**TOWN OF BAY HARBOR ISLANDS
MORRIS N. BROAD COMMUNITY CENTER
1175 95TH STREET
BAY HARBOR ISLANDS, FL 33154**

DEVELOPMENT & REVIEW COMMITTEE MEETING

**TOWN OF BAY HARBOR ISLANDS
COMMUNITY DEVELOPMENT
MEMORANDUM**

Subject: Site Development Plan Application
1085 Townhouses – 6 DU Townhouse Complex
1085 94th Street
Bay Harbor Islands Acct. No. SPR24-000025
MMPA Account No. 01-0702-1197

ROOF PLAN

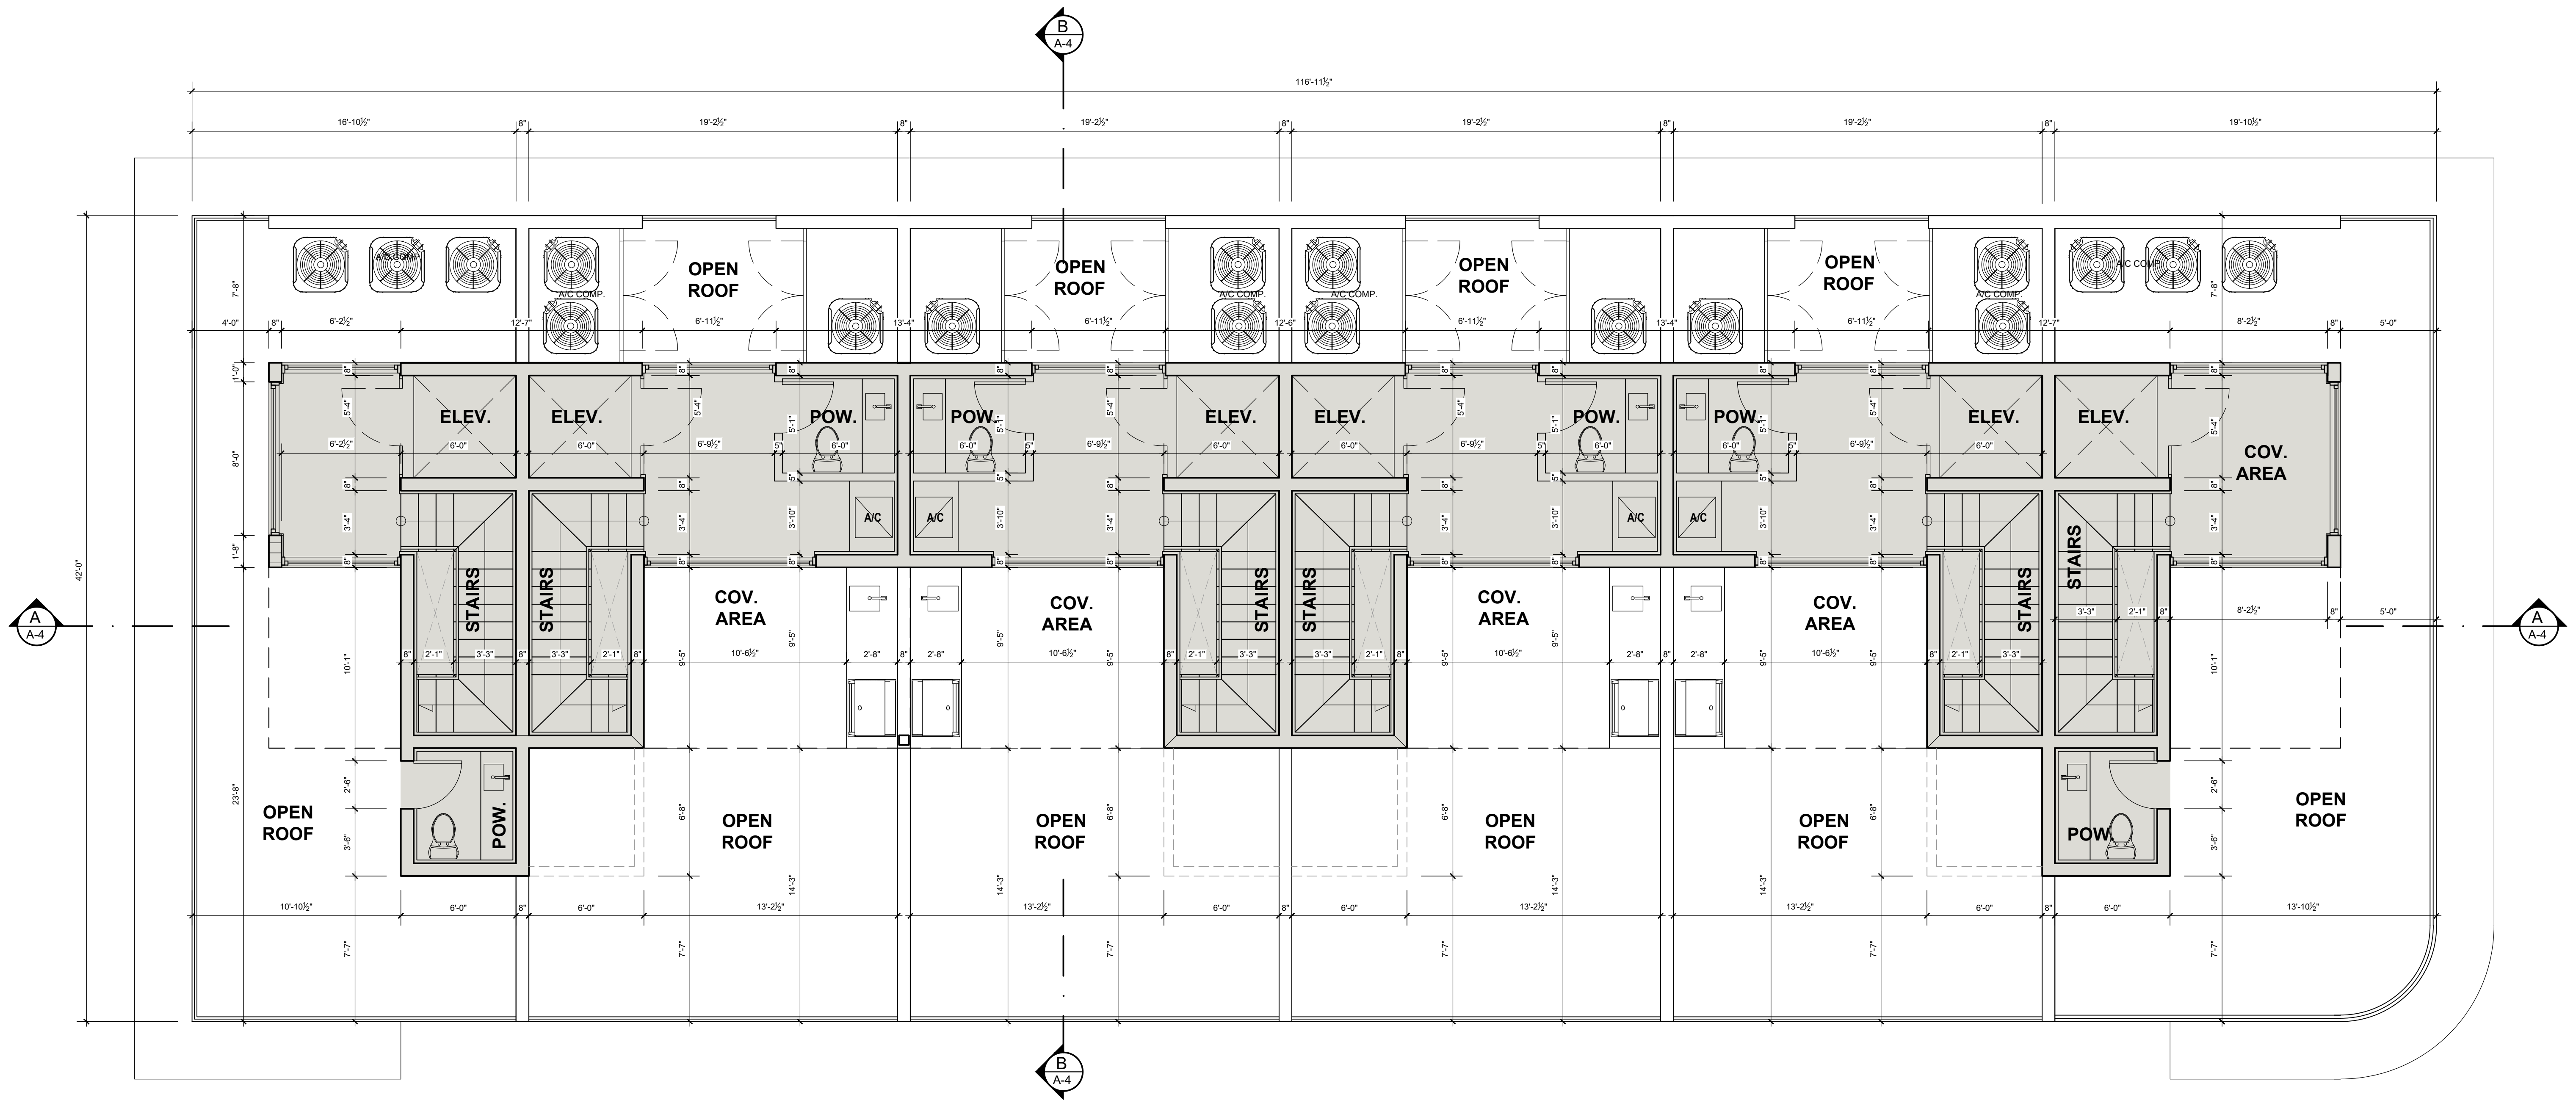
- 5) As noted above the rooftop areas show undefined "open roof" areas. Rooftop recreation areas must have at least 15% of the areas used for recreation landscaped. Clarify the intended use of the rooftop areas. Revise the plans to add landscaping to the roof and add this calculation to the Landscape Requirements table as well as the roof plan.
